Our Reference: 8017172

PA2017/5637 – Aspire Estate Stage 36A - Functional Layout Plan – Approval

The above-mentioned plans, received by Council on 29 March 2022, are approved.

Drawing No.	Revision
8226 E/36A Sheets 1-3	P3

PASSIVE IRRIGATION INLET DETAIL
SCALE - 1:20

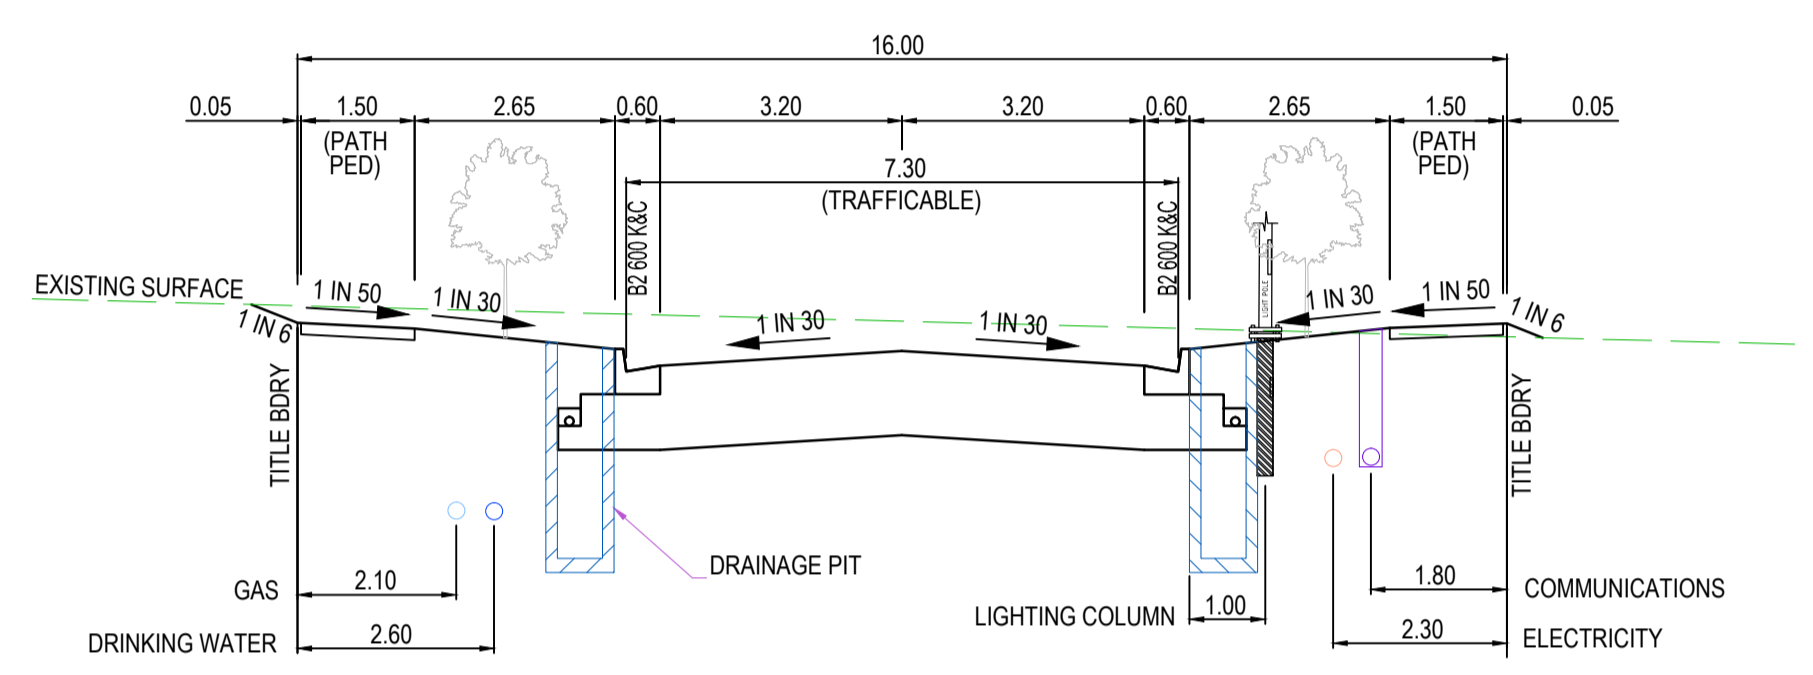
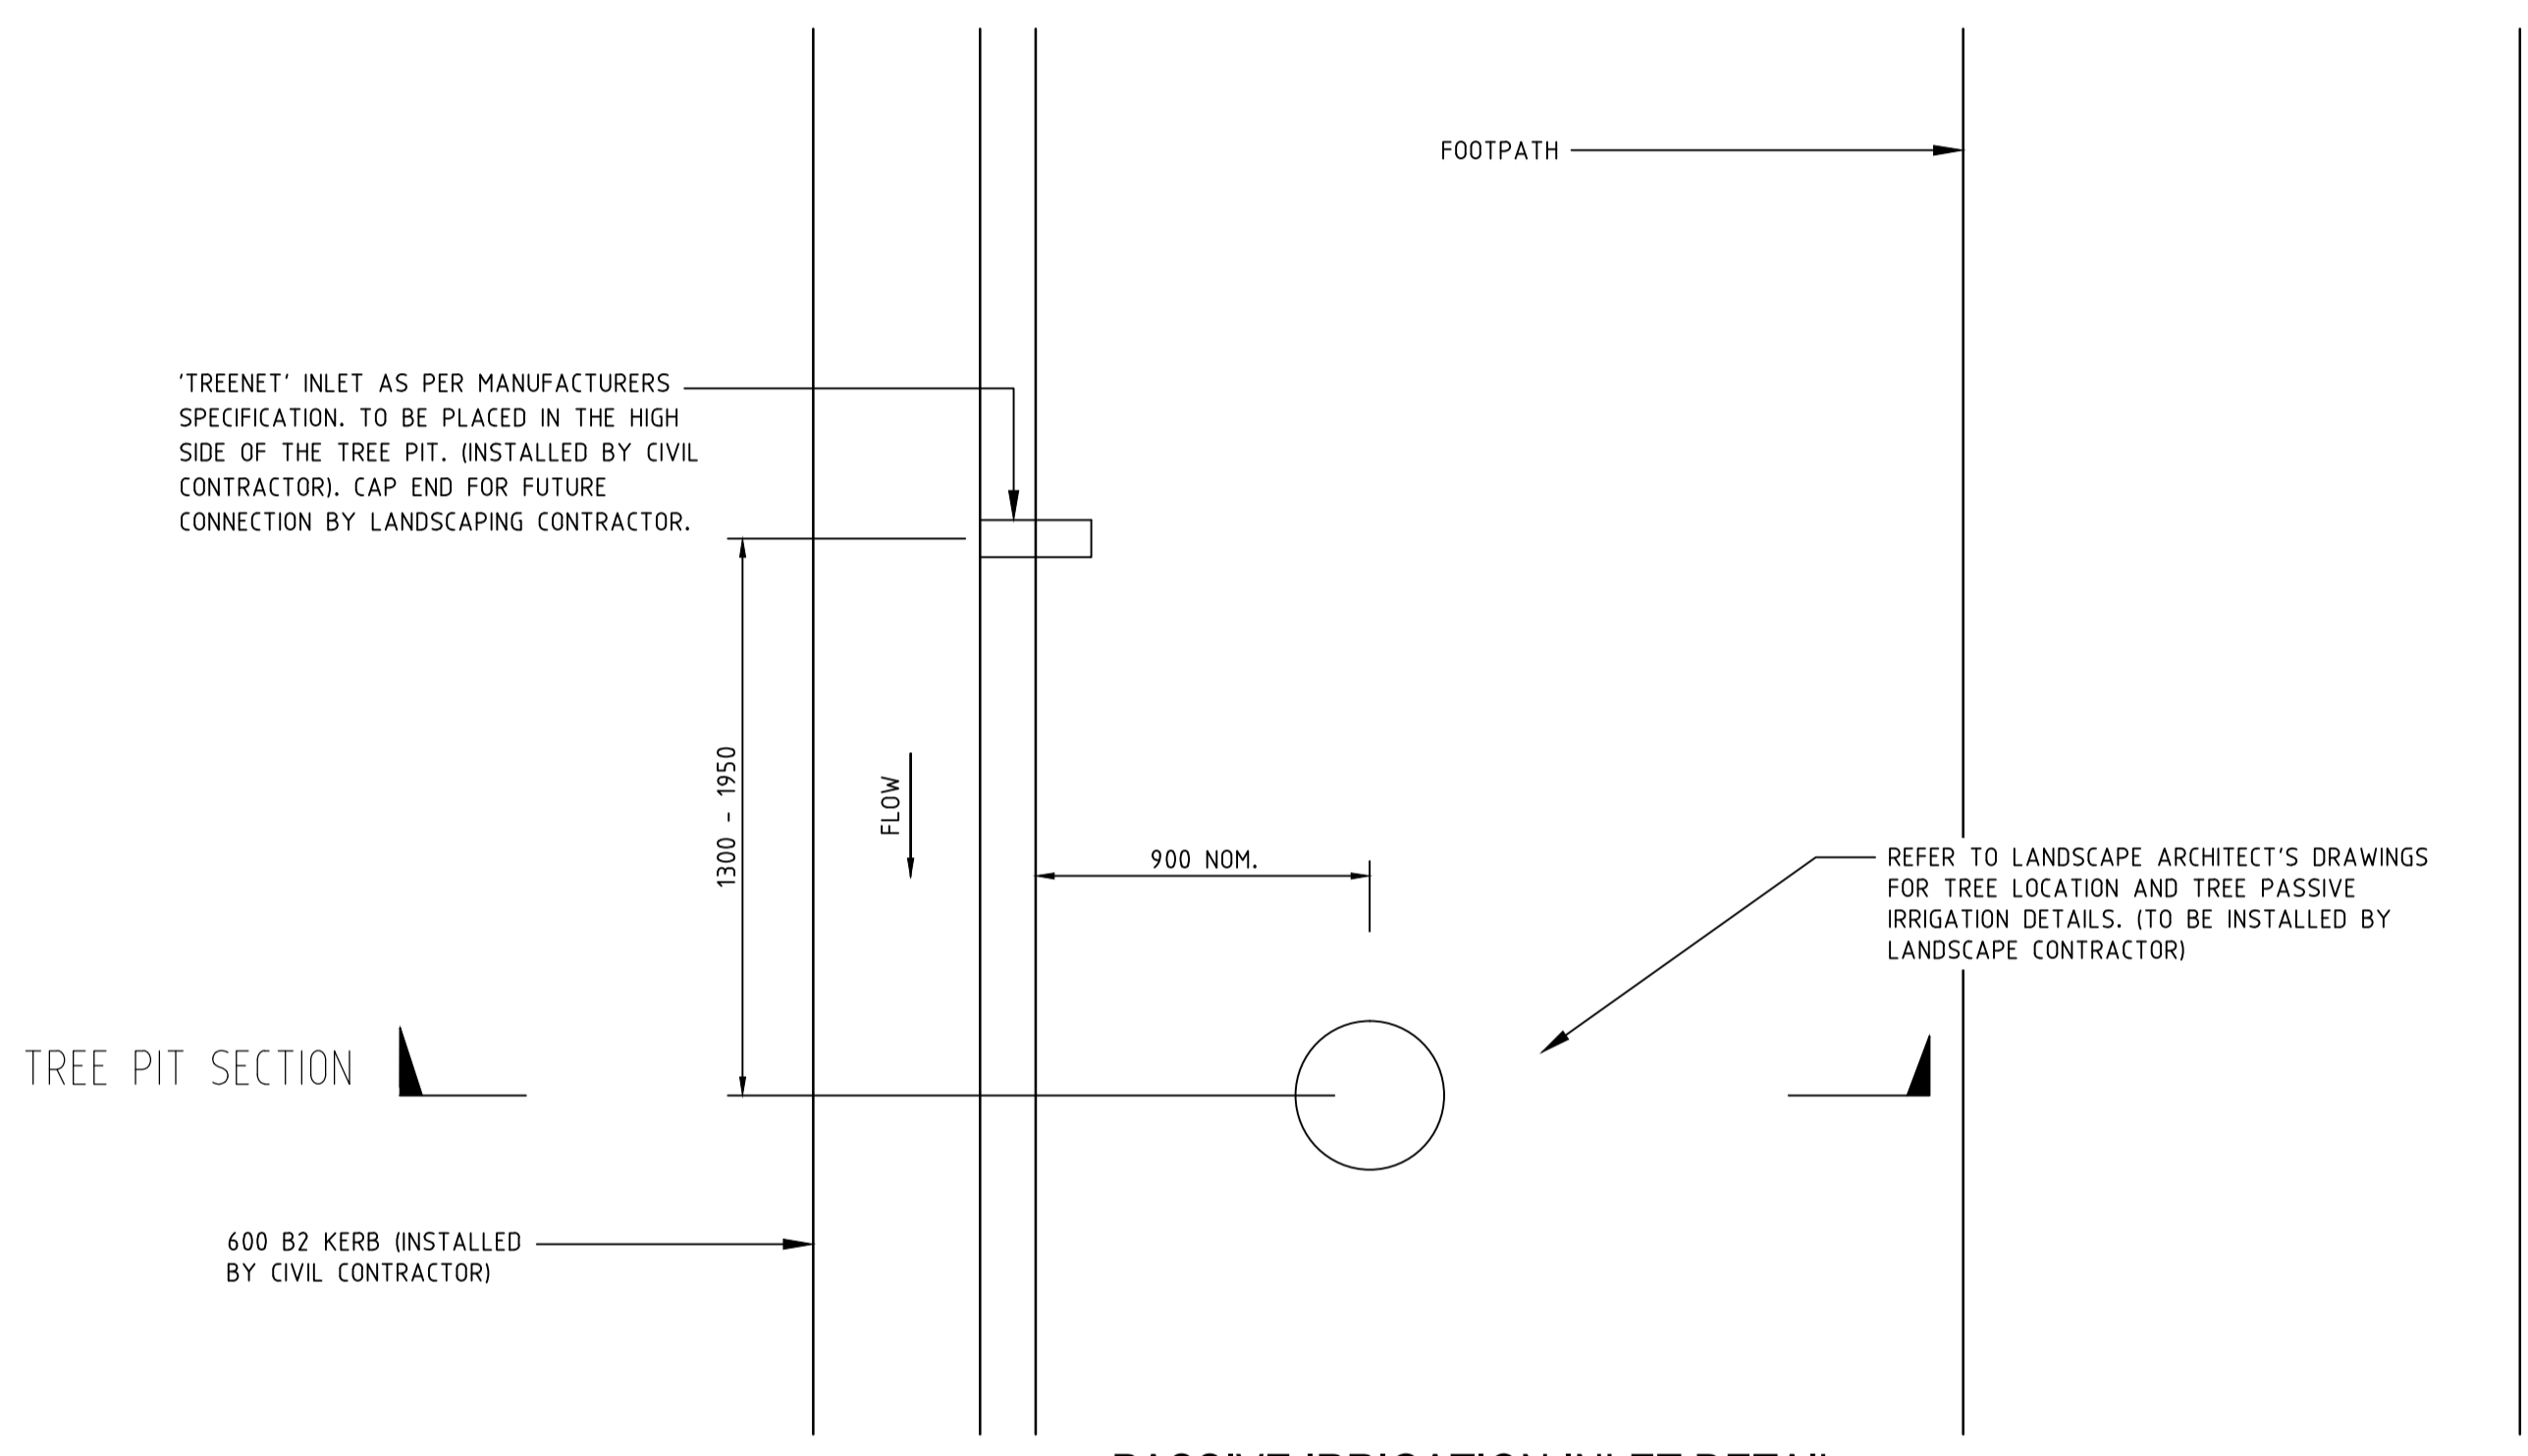
Details and locations of street tree passive irrigation must be shown on the detailed engineering plans consistent with the approved Integrated Water Management Plan and landscape plans. Clearly separate the components that will be constructed under the civil works and landscaping works. Council reserves the right to ask additional changes during the detailed engineering stage, to maximise the street tree passive irrigation deemed necessary.
